Re: Response to Town Review Comments
Dolley Farm Subdivision
25 River Road, LLC – Applicant

On behalf of 25 River Road LLC, we have prepared this letter and attached information in response to the comments presented in the Application Completeness & Staff Review Comments Memo dated August 5, 2025.

UNIT 1 AND 15 ELEVATIONS FACING RIVER ROAD

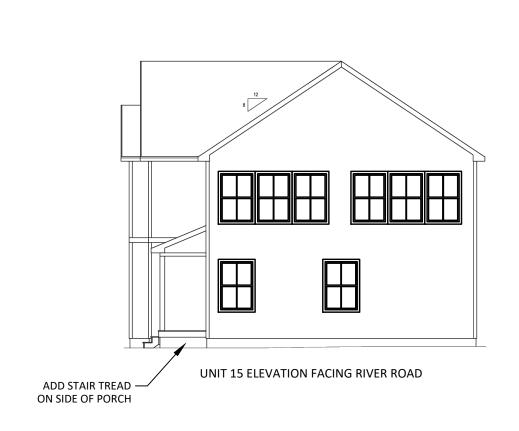
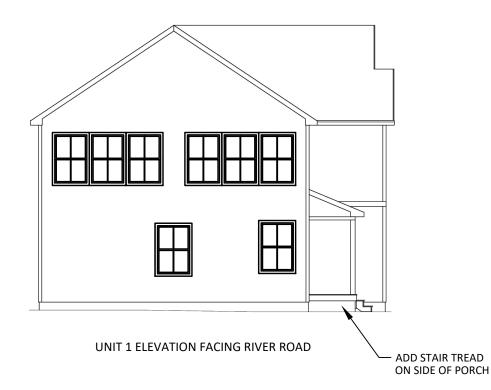
<u>Comment #4A</u> – In the May 30 response to staff comments on the building orientation required by Section 120-814A(3)(a) and the street facing facades 25% minimum fenestration required by Section 120-814A(2)(d),

Response # 13 stated that, "The building plans for Units 1 and 15 are being designed with a wrap-around front porch element so that the main entrance is on Dolly Farm Road but the porch element wraps around the side of the building to create the look of a front entrance facing River Road. We are also adding additional windows to the west side of Units 1 and 15 to meet the fenestration requirement. Updated building plans will be provided with the Final Site Plan Application." The final plan submission does not include updated building architectural plans and the wrap around porch detail is not shown on the final site plan.

Response #4A — Attached is an elevation drawing of Units 1 and 15 depicting the sides of the buildings that will face River Road. We have added windows to meet the 25% fenestration requirement, and calculations will be provided when buildings permits are applied for so that the fenestration area can be confirmed. The wrap-around porch that was contemplated during preliminary plan review is not proposed to be built on these buildings because the proposed porch that extends all the way to the corner of the building closest to River Road will provide sufficient architectural detail to create the appearance of an entry that is accessible from the street side of the building. We have discussed this approach with the Planning Board on several other similar projects and the consensus has been to align the front of the units to the access drives.
